**METROPOLITAN GOVERNMENT OF NASHVILLE AND DAVIDSON COUNTY**

**STAFF RECOMMENDATION**  
**1630 Douglas Avenue**  
**June 19, 2013**

**Application:** New construction - infill  
**District:** Eastwood Neighborhood Conservation Zoning Overlay  
**Council District:** 06  
**Map and Parcel Number:** 08302018000  
**Applicant:** Brent Craig, Developer  
**Project Lead:** Sean Alexander, sean.alexander@nashville.gov

**PLOT PLAN  
 FOR  
 PART OF LOTS 113 & 114  
 DR. E.T. BROWN'S SUB.  
 OF LOTS 21-26  
 BROWNSVILLE ADDITION  
 P.B. 332, PG. 91  
 6TH COUNCIL DISTRICT  
 NASHVILLE-DAVIDSON COUNTY-TENNESSEE  
 SCALE: 1"=30' DATE: 6-3-13  
 HFR PROJECT NO. 2013086**

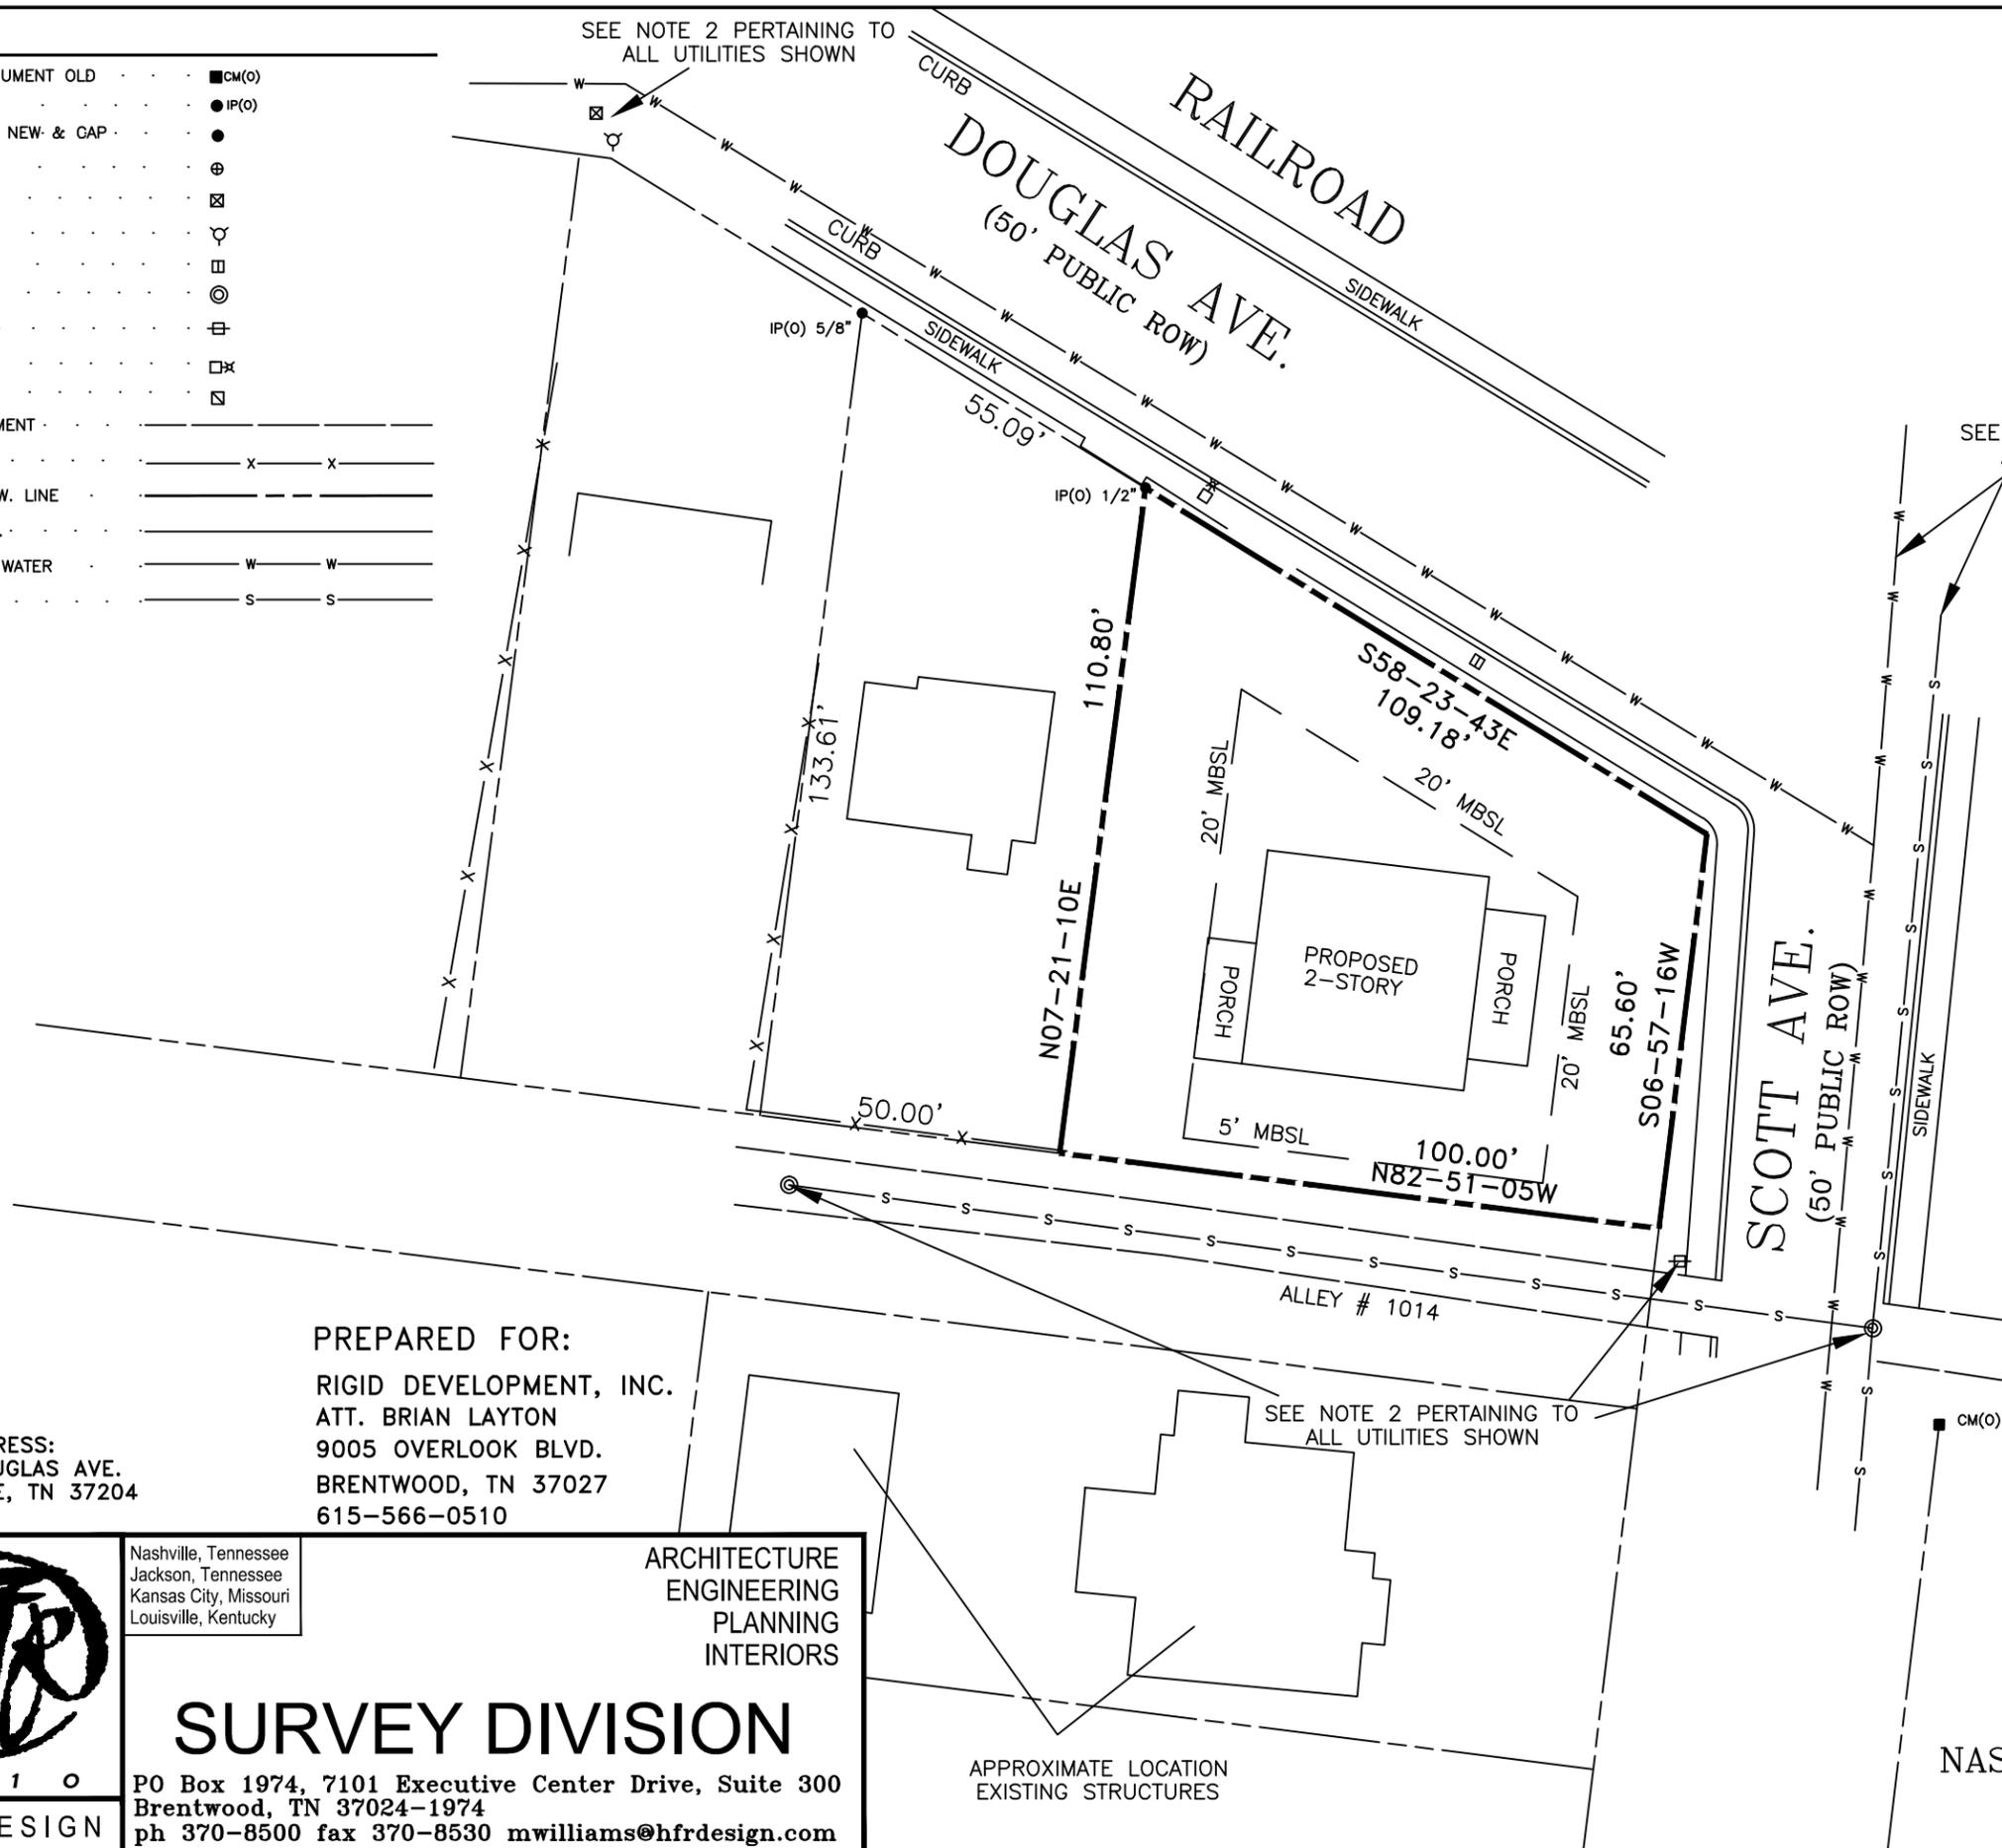
The front setback of the proposed house on Scott Avenue will be twenty-four feet (24'). The house directly adjacent at 415 Scott Avenue has a front setback of thirty-six feet (36'), however, all other historic houses on Scott Avenue have a setback between twenty and twenty-five feet (20'-25'). The side setbacks will be twenty-feet (20') on the left side along an alley, and the right side setback along Douglas Avenue will vary due to the irregular shape of the lot. These setbacks meet the current zoning regulations and maintain the rhythm of spacing established by historic houses in the area.

The submitted plans do not indicate any paving for driveways, parking, or sidewalks. These items can be reviewed administratively. With a condition that the driveway, parking area, and sidewalk are approved administratively, staff finds that the proposal meets guideline II.B.1.c.

- The details of roof color and the materials of the windows, front and rear porch floors, porch railings, as well as exterior appurtenances are approved administratively,
- The driveway, parking area, and sidewalk are approved administratively.

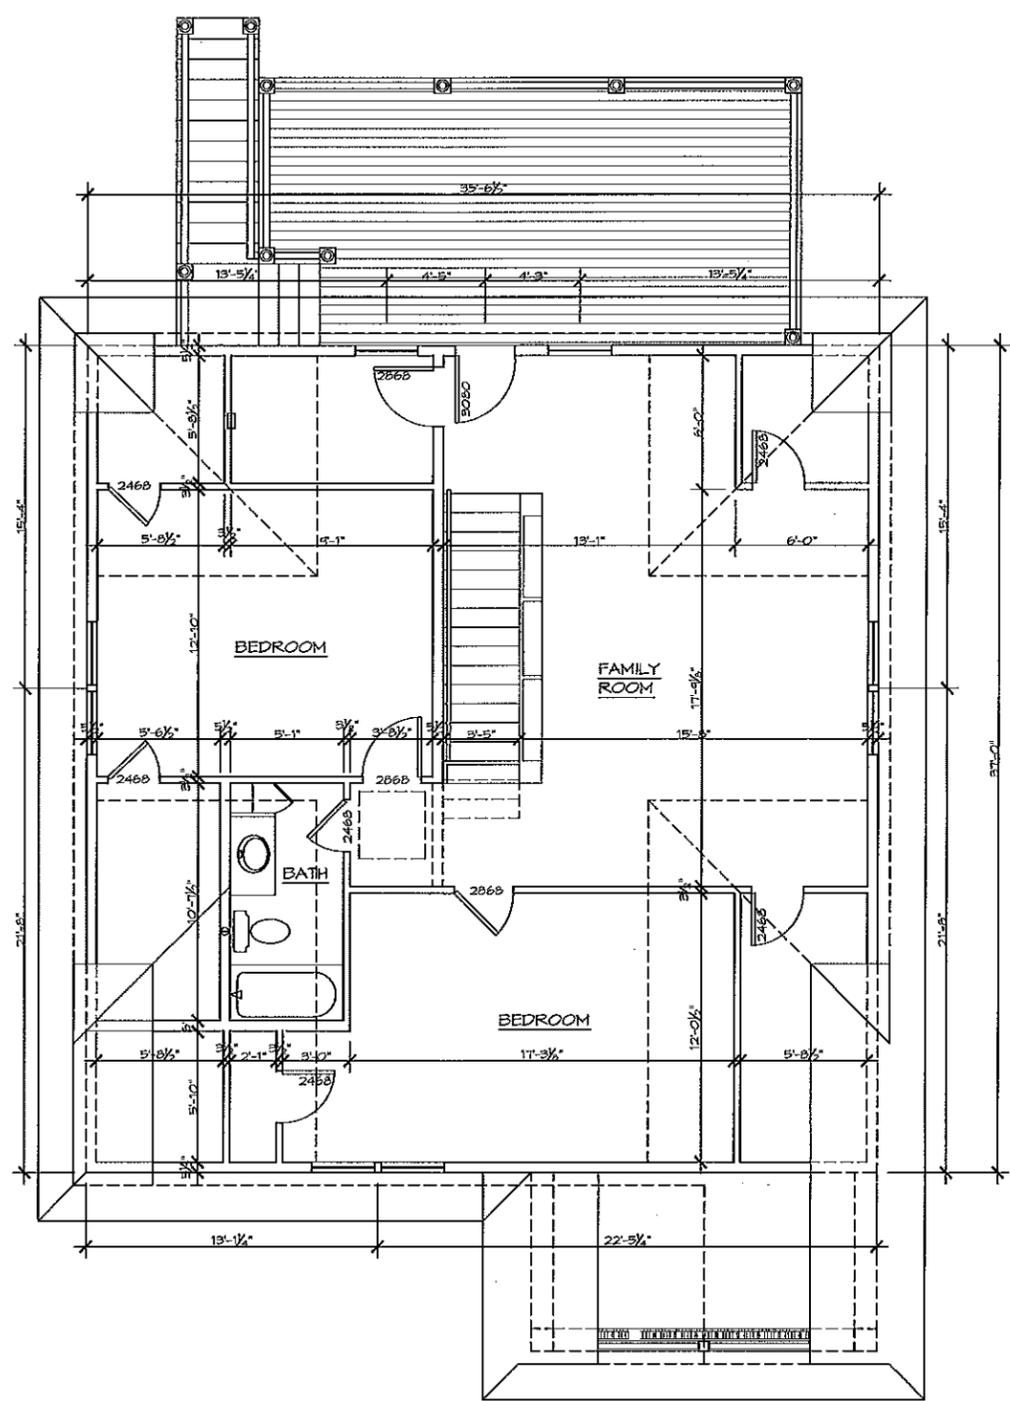
The tallest point of the house, a primary front-to-back roof ridge, will be thirty-two feet, six inches (32'-6") above grade, with a two-course tall foundation. A secondary roof ridge will meet the side slopes of the roof at two feet, six inches (2'-6") below the primary roof ridge. With this minimal difference in roof heights, the house will read as if it has a cross-gabled roof, a common form among historic houses. The roof sections will have clipped gables and an eave height of twelve feet, six inches (12'-6").

The house will be nearly square with a thirty-five foot, six inch (35'-6") wide front elevation, running thirty-seven feet (37') deep into the lot.

The roofs of the new building will be 12:12 pitched clipped gables, which are compatible with surrounding historic houses and meet guideline II.B.1.e.

The windows openings on the front and side elevations are roughly twice as tall as they are wide, and the openings are spaced in a manner consistent with historic houses in the

area. The front door will be in the center of the front elevation, balanced by sets of windows on either side. The window sizes and patterns on the side elevations are also compatible with surrounding historic houses. These openings meet guideline II.B.1.g.
